ELECRAFT KPA100 UPGRADE INSTRUCTIONS ERRATA

Rev. A-6, November 9, 2007

THESE MANUAL CORRECTIONS MUST BE MADE BEFORE YOU BEGIN ASSEMBLY OR YOUR KPA100 MAY NOT FUNCTION CORRECTLY

Figure 2. Input and Feedback Circuit Component Changes.

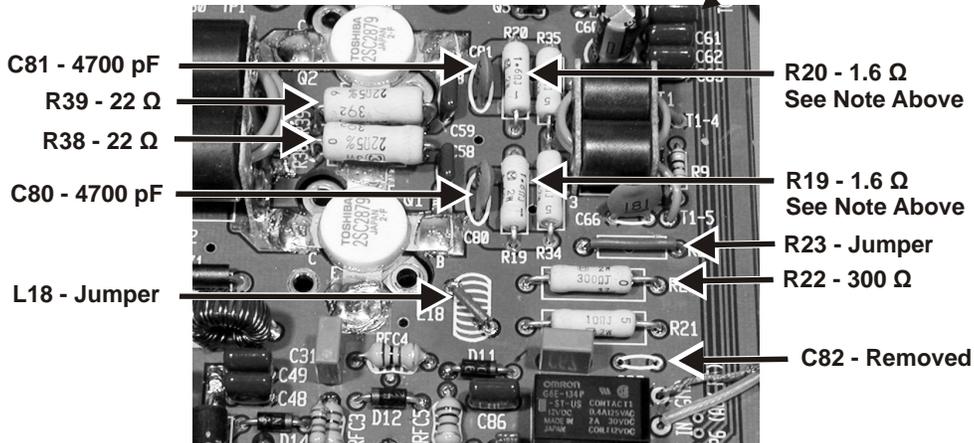
4. **Page 4, Note at top of page:** Delete "Proceed directly to Part III if these changes have been made. Otherwise follow the procedure below to make the changes".
5. **Page 4, Figure 2:** Cut out the new figure 2 below and paste it over figure 2 in the manual.

NOTE: Replace R19 and R20 even if you already have the correct value resistors installed. The resistors supplied have low-inductance properties required for your KPA100 to operate correctly.

Figure 5. T/R Switch Components.

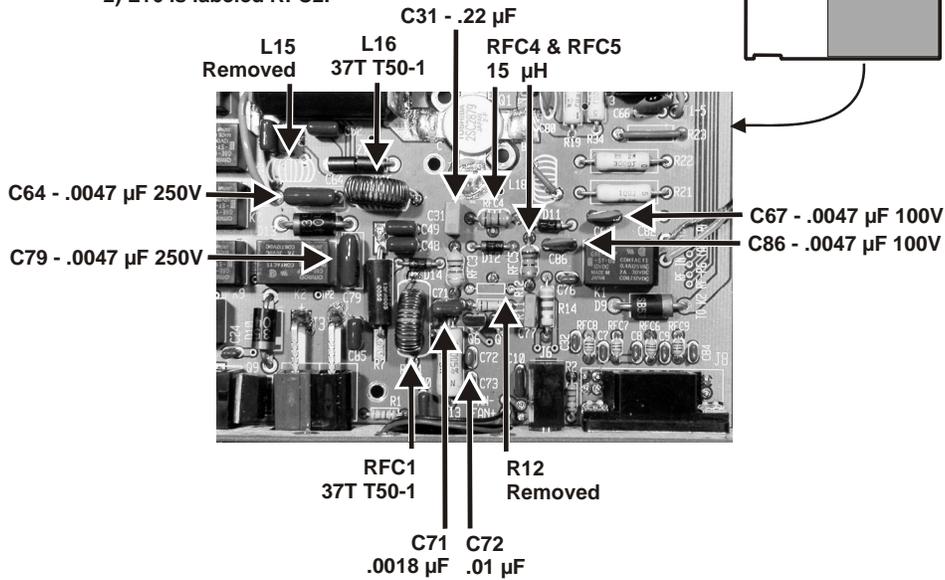
7. **Page 6, Figure 5:** Cut out the new figure 5 below and paste it over figure 5 in the manual.

NOTE - If you have a Rev A PCB:
 1) L15 has no reference designator shown on the board.
 2) L16 is labeled RFC2.
